SUBMITTAL SUMMARY REPORT 33059

PLAN NAME: ON TOP OF THE WORLD - SKYE AT CANDLER HILLS WEST **LOCATION:**
APPLICATION DATE: 07/10/2025 **PARCEL:** 35300-000-00
DESCRIPTION:

PRELIMINARY PLAT - SKYE AT CANDLER HILLS WEST
ON TOP OF THE WORLD
MARION COUNTY, FLORIDA

SHT. 03.05

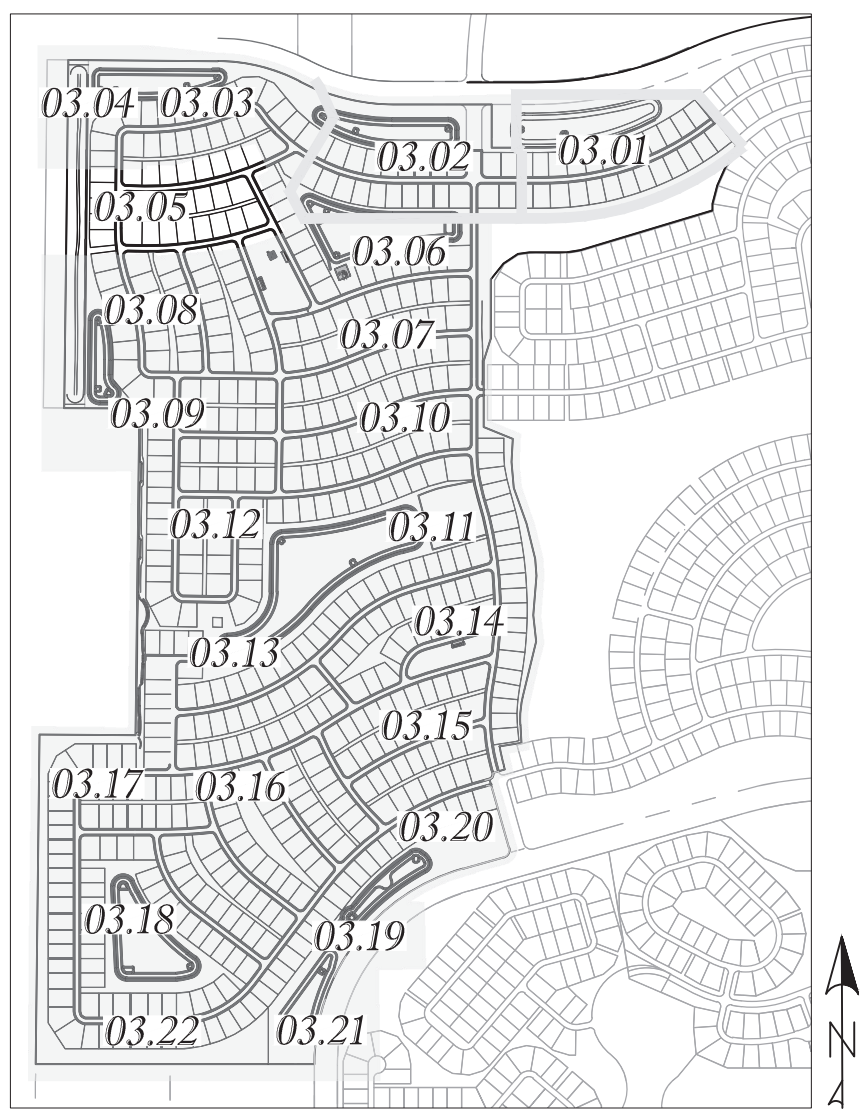
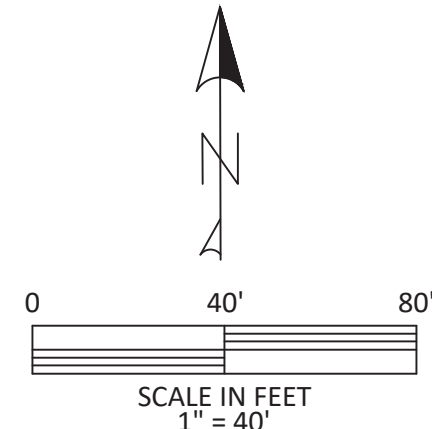
3) The plat identifies "well site #2" lying west of the plat area (e.g., Sheets 3.04, 3.05, 3.08, 3.09) that appears to be intended to be a stand alone parcel; however, it will require being appropriately platted/replatted as well. PLEASE PROVIDE AN EXPLANATION as to why that well site #2 is not being included in this plat.
N/A 4.1.4.J - [Greenway Setback Provided?]
N/A 2.12.16/6.5 - [EALS or EALS-ER provided?]
N/A 6.5 & 6.6 - Habitat Preservation/Mitigation Provided?
N/A 2.12.9 - [Show All Existing Surrounding & Intersecting R/Ws?]
N/A 6.12.2.A - [Local Road right-of-Way Provided?]
N/A 6.12.2.A - [Access Improvements R/W Provided (decel/accel/turn lanes)?]
N/A 2.12.9/6.12.2.B - Comp Plan Future Thoroughfares R/W Provided (TE Map)?
N/A 6.11.4.C - [Additional/Alternate/Interconnected Access (S/QS-L) Provided?]
N/A 6.11.2, 4 & 5 - Internal Access Consistent with PUD/Master Plan/Plat?
N/A 6.11.4.B & D/7.3.1 - [Cross/Parallel Access Provided?]
